Originator's  
Files OZ 04/037 W2

**SUBJECT:** **Official Plan Amendment and Rezoning Applications**  
**To permit two 18 storey residential condominium buildings**  
**containing 424 apartment units and a community park**  
**1075 Southdown Road and 2007 Lakeshore Road West**  
**Northeast corner of Lakeshore Road West and Southdown**  
**Road**  
**Owner: Stonebrook Properties Inc.**  
**Applicant: Glen Schnarr and Associates Inc.**  
**Bill 20**

**Supplementary Report** **Ward 2**

SITE PLAN

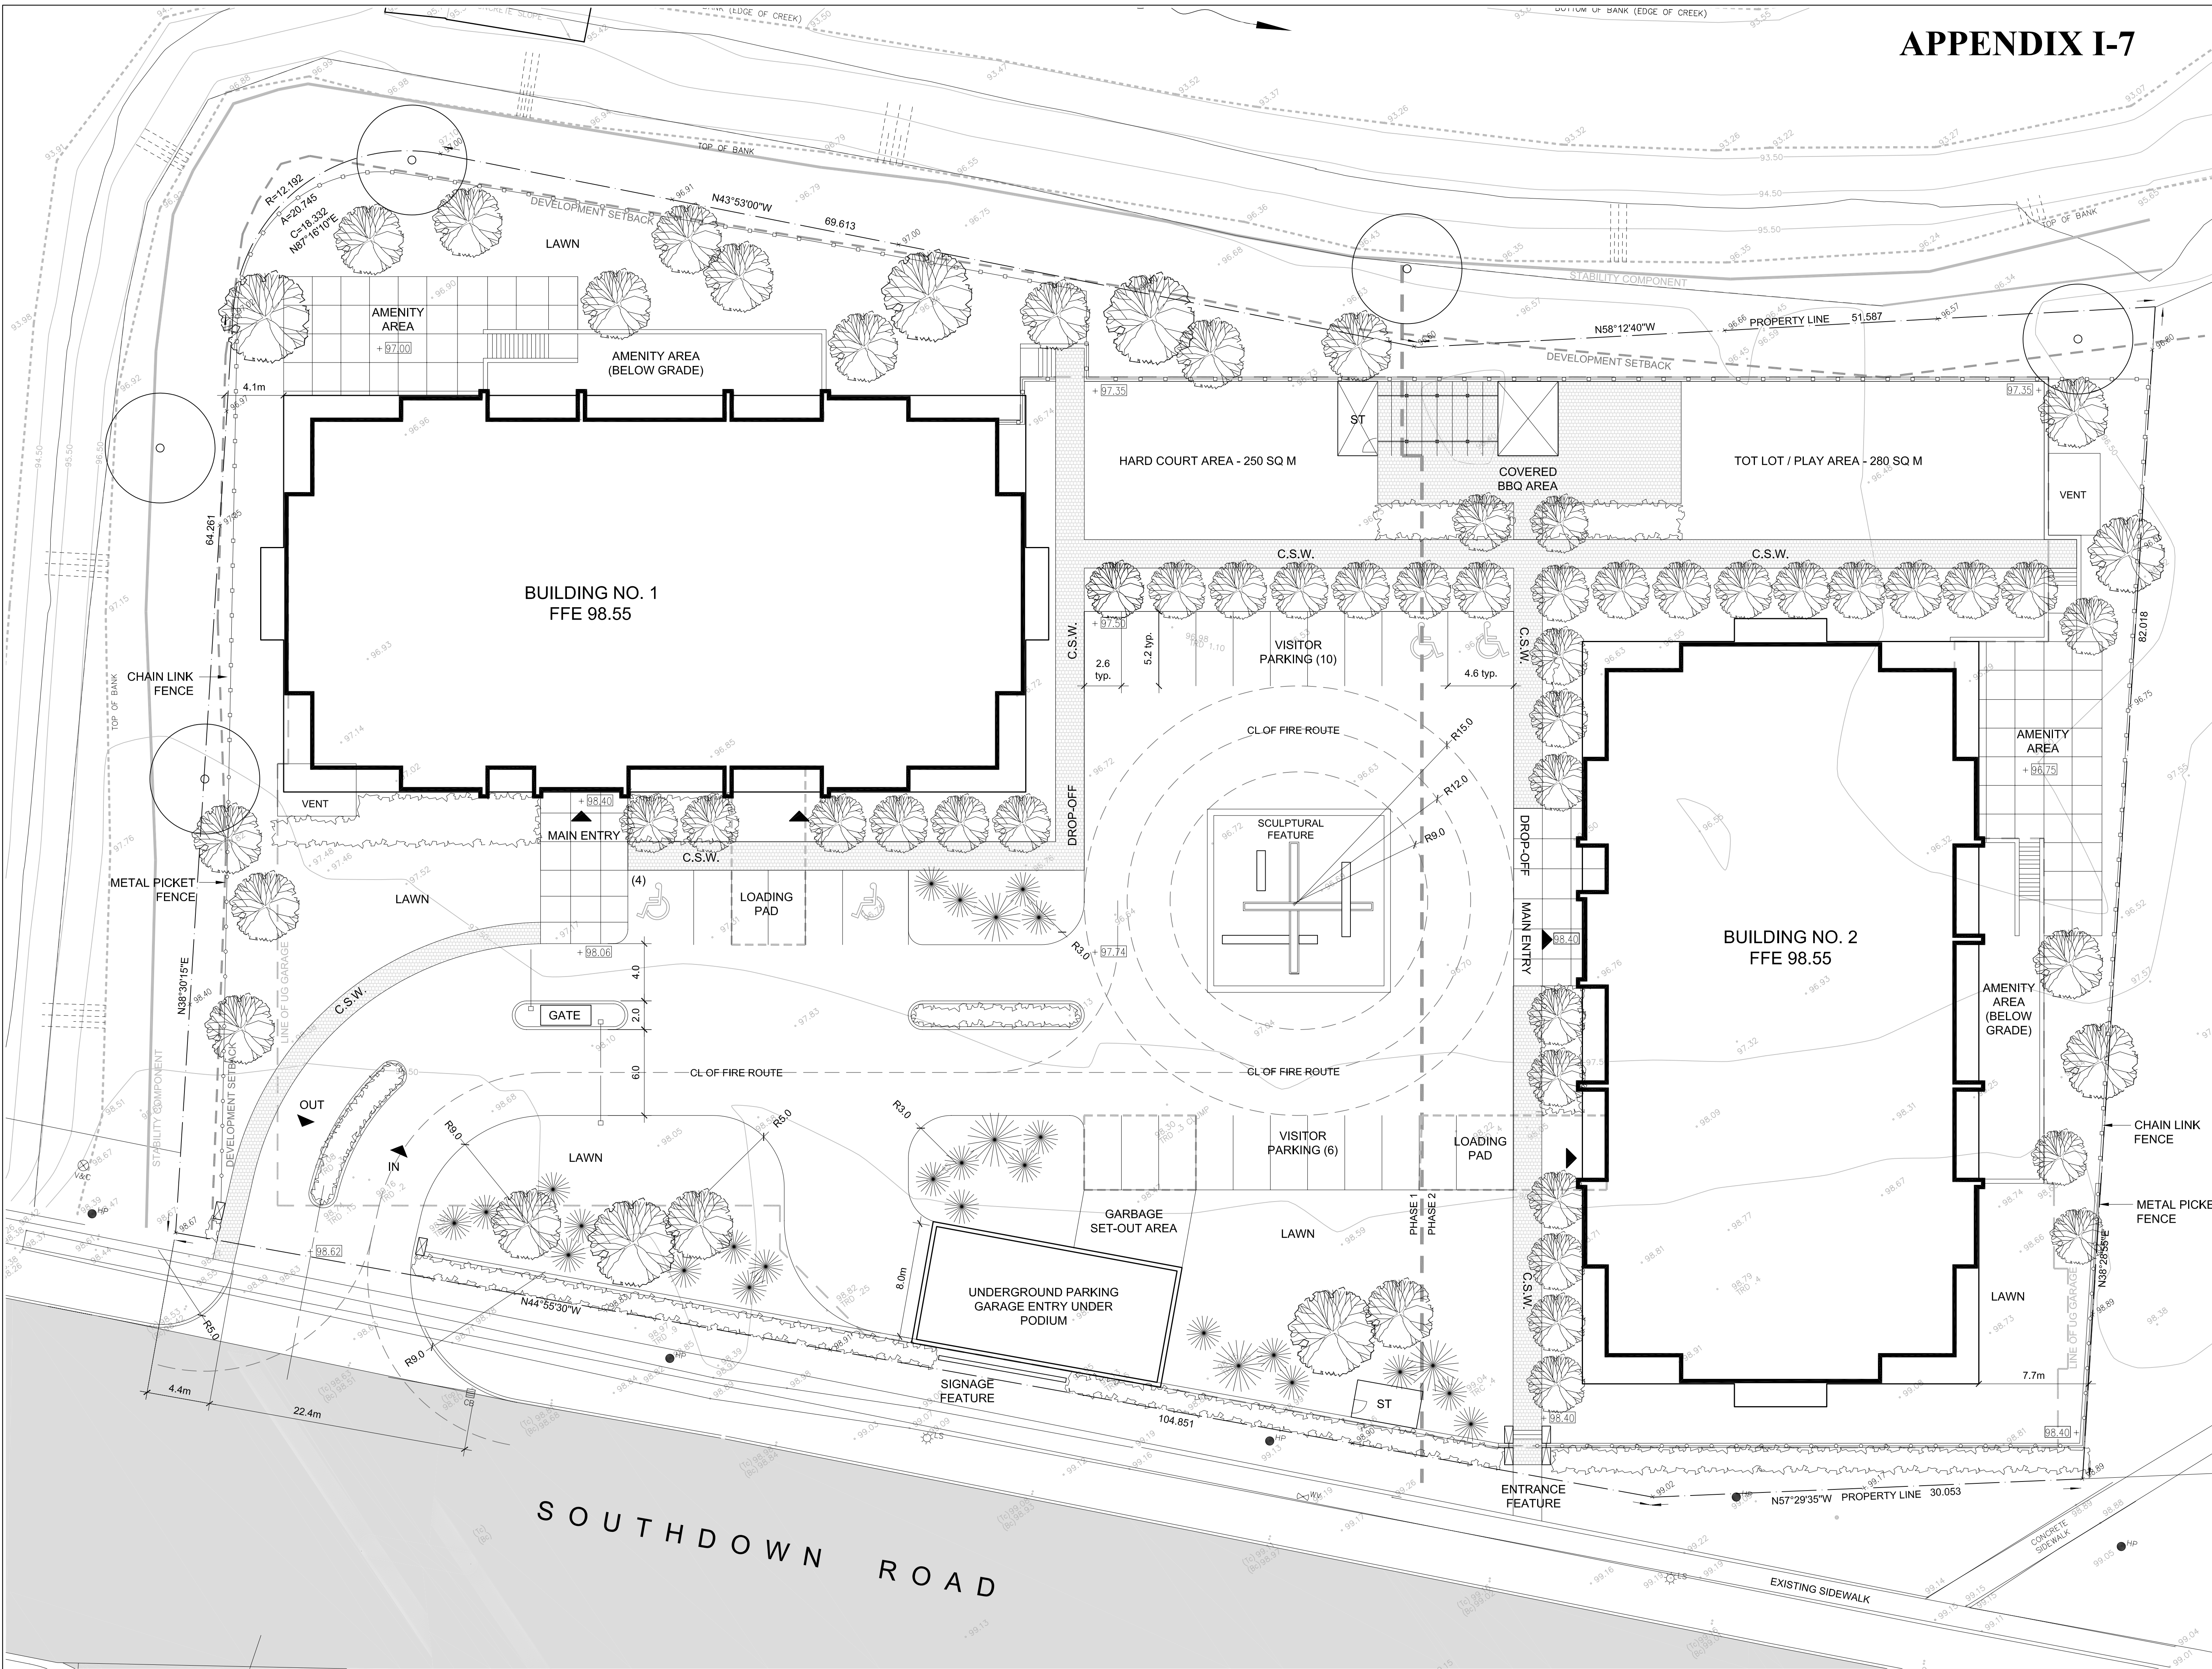
Consideration should also be given to relocating the underground parking garage entrance structure, which is currently shown on the concept site plan as being setback only 1.0 m (3.3 ft.) from the front property line. This one storey structure will isolate the site from Southdown Road and minimize opportunities to promote desirable street related connections and safety.

The concept site plan also depicts a 0 m (0 ft.) setback for the underground parking structure from the required development setback. Credit Valley Conservation (CVC) has indicated that all lands below the development setback limits should come into City ownership should the applications be approved. To accommodate the proposed underground structure, excavation, shoring and grading activities would be required within City owned lands contrary to CVC requirements. An alternative solution will need to be achieved prior to preparing the Supplementary Report for Planning and Development Committee's consideration.

- the number of parking spaces proposed in a tandem configuration has been increased from 11% to 15% of the total parking provided;
- the minimum front yard setback to the underground parking structure has been increased from 0.7 m (2.3 ft.) to 1.2 m (3.9 ft.);

- the minimum side yard setbacks to the underground parking structure have been increased from 1.0 m (3.3 ft.) to 3.0 m (9.8 ft.);
- the minimum rear yard setback to the underground parking structure has been increased from 2.0 m (6.6 ft.) to 3.0 m (9.8 ft.); and,
- a 5.0 m (16.4 ft.) structural setback from Sheridan Creek is to be conveyed to the City of Mississauga, retaining the existing "G" (Greenbelt) zoning.

The intent of the increased southerly side yard setback to the garage is to ensure that proposed construction activities will not encroach into the abutting Twin Spruce Park. The setback is appropriate provided that hoarding, tree protection/removal and replacement provisions are addressed prior to the commencement of construction and that all above ground structures maintain at least a 6.0 m (19.7 ft.) setback.

- that the required setbacks from the Sheridan Creek corridor (rear and north side yards) be increased from 3.0 m (9.8 ft.) to 6.0 m (19.7 ft.), which may be reduced to 3.0 m (9.8 ft.) if supported by the required restoration and rehabilitation plan, and;
- that the lands located within the rear and north side yards be identified on a Schedule "I" to the implementing zoning By-law as a tree preservation and protection area to ensure that any plantings associated with the restoration and rehabilitation plan are preserved over the long term.
